Docket No: 70-1257
Applicant: Exxon Nuclear Company (ENC)
Facility: Fuel Fabrication Plant, Richland, Washington
SUBJECT: REVIEW OF APPLICATION TRANSMITTED BY LETTER DATED NOVEMBER 19, 1979, SUPPLEMENTED FEBRUARY 21, AND MARCH 12, 1980, CONCERNING ION EXCHANGE, ACCOUNTABILITY STATION AND WASTE RECOVERY, 07001257A03S

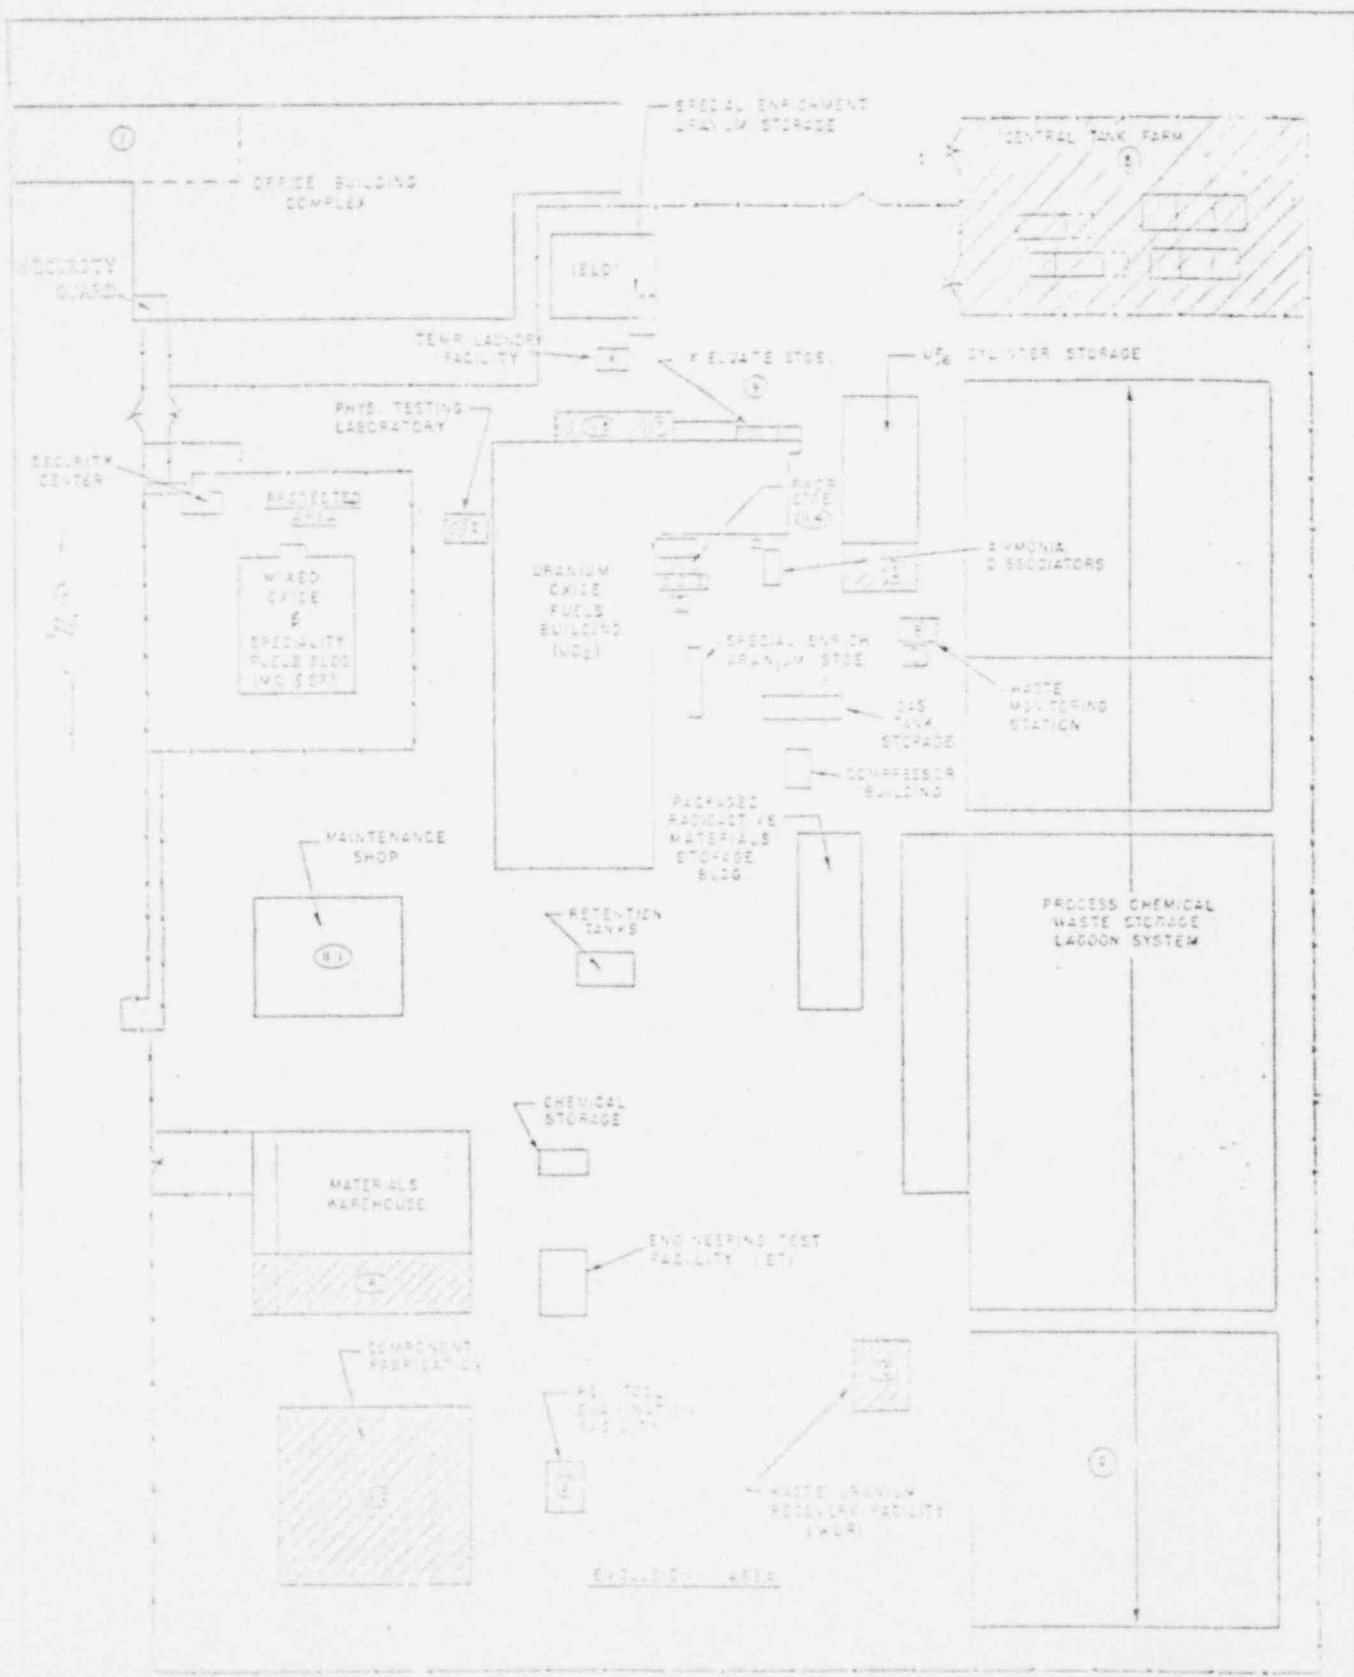
The locations of the new facilities and equipment are shown on the attached site plan as Items 8, 9, and 10.
